Ref: FCC Class II Permissive change for FCC ID: QDS-BRCM1058
(Original Grant Date: 6/29/2011)
Applicant: Broadcom Corporation

This is to request a Class II permissive change for FCC ID: QDS-BRCM1058. There are no hardware or electrical modifications made to the applying modular transmitter.

The major change filed under this application is:

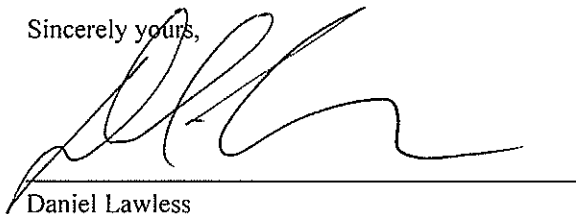
1. The subject approved module is being used in different host (Portable category Configuration, Host Bran/Model: See test report) with a closer antenna to end user distance of 5.7mm.
2. Antennas of the same type, PIFA, with less gain than antennas of previously authorization are installed into the host of laptop platform. The gain of the respective antennas is listed as follows:
Original Gain: 3.9dBi in 2.4GHz, 5.8dBi in 5GHz.
Main: Type: Maximum Gain: 2.15dBi(2.4G). , Aux: Type: Maximum Gain: -0.39dBi(2.4G).
Main: Type: Maximum Gain: -1.06dBi(5.2G). , Main: Type: Maximum Gain: -0.82dBi(5.6G).
Aux: Type: Maximum Gain: -1.67dBi(5.2G). , Aux: Type: Maximum Gain: -2.05dBi(5.6G)
3. SAR Testing is performed to demonstrate RF Compliance.

4. This project has two host labels: 65W is for UMA and 90W is for DIS, two hosts use the same motherboard, the difference is the graphic chip is SMT or not.
